भारत सरकार - रेल मंत्रालय
अनुसंधान अभिकल्प और मानक संगठन
लखनऊ - 226011
Government of India - Ministry of Railways
Research, Designs & Standards Organization,
LUCKNOW - 226011

MODIFICATION SHEET NO. RDSO/2011/EL/MS/0404 Rev '0'

Modification in electric locomotive control circuit fitted with microprocessor based control system (MPCS) for individual isolation of hard/soft QDs during operation of HMCS programme switch.

REF.	PART NO.	DESCRIPTION	DETAIL DRG. NO./LOC.	HALT.	SPEC.
REF.	SMI/0— (Rev '0')		SCALE	APPD. BY <i>28/12/11</i> (FOR DG)	
Loco control circuit for separate isolation with hard QDs through HMCS.			FIRST ISSUED		
			SUPERSEDES		
			SUPERSEDED BY		
RDSO. ELECT. DTE.			SKEL-4869

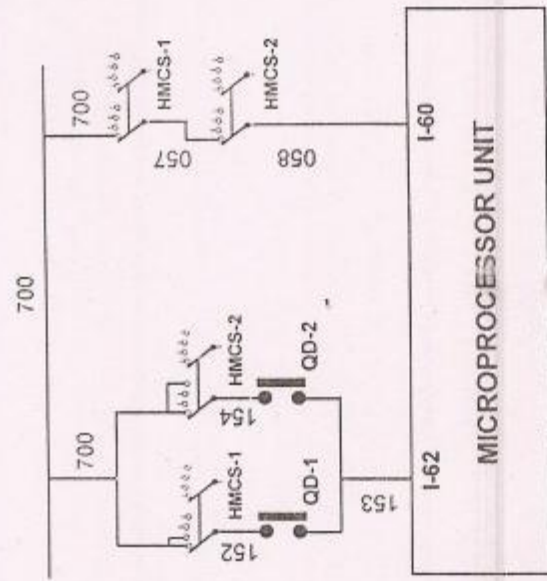
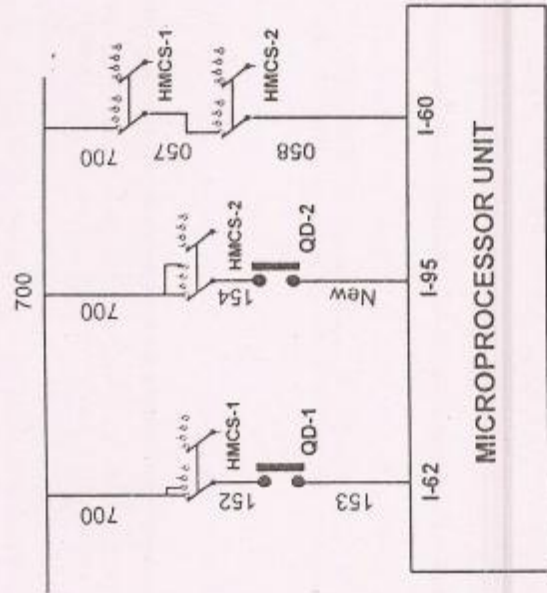
(B) For Hard QDs:-

Remove parallel combination of HMCS-1 & 2 from input I-62 along with QD-1 & QD-2 in existing circuit as shown in SKEL-4869. Series arrangement of HMCS-1 & 2 from input I-60 remains same for DBR mode operation.

HMCS-1 should be connected directly to wire no. 700 and wire no. 152 along with QD-1 in series with wire no. 153 should be connected to input no. I-62. Similarly HMCS-2 should be connected to wire no. 700 and wire no. 154 along with QD-2 in series with wire no. 'new' should be connected to input no. I-95 in modified circuit as shown in SKEL-4869.

Change in software logic should be carried out simultaneously.

Automatic recognition for soft QD and Hard QD by software: Software should be modified in such a way that MPCS system act on soft QD when ISCU communication is available otherwise act on hard QD

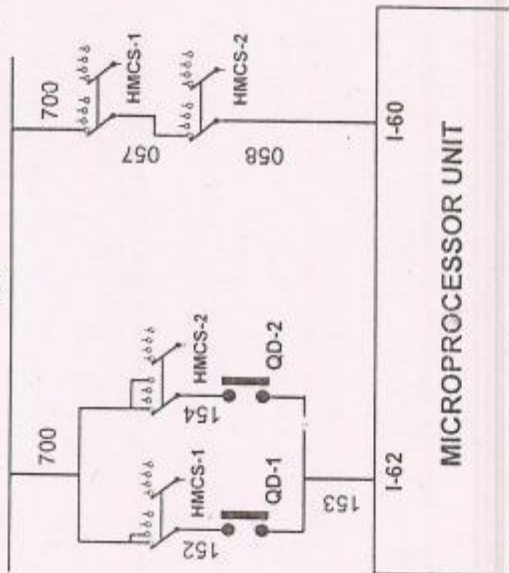
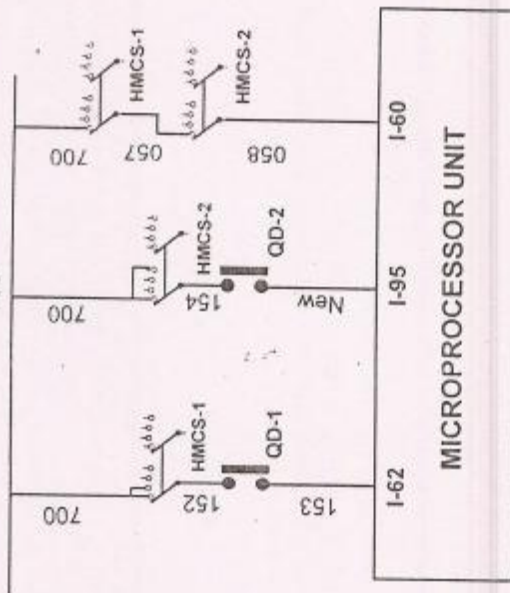
(A) For soft QDs:-

Remove parallel combination of HMCS-1 & HMCS-2 from input I-62 in existing circuit as shown in SKEL-4868. Series combination of HMCS-1 & HMCS-2 from input I-60 remains same for DBR mode operation.

HMCS-1 should be connected directly to wire no. 700 and wire no. 153 should be connected to input no. I-62. Similarly HMCS-2 should be connected with wire no. 700 and wire no. 'new' should be connected to input no. I-95 as shown in modified circuit as shown in SKEL-4868.

Change in software logic should be carried out simultaneously.
